Product / Process Change Notification (PCN)

PCN #: PCN_FeCBF1812_20211013

Affected Series: WE-CBF; 7427925xx

Packaging Specification - Tape: [mm]

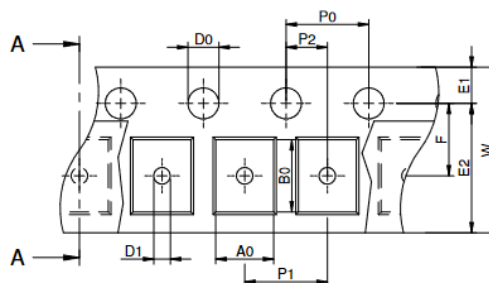
Because of a database mismatch, Würth Elektronik will correct the packaging dimension.

Updating the packaging specification for the value P1 in the size 1812. There is no change in the packaging dimension.

Before Change	After Change
P1 (mm)	P1 (mm)
4,00	8,00
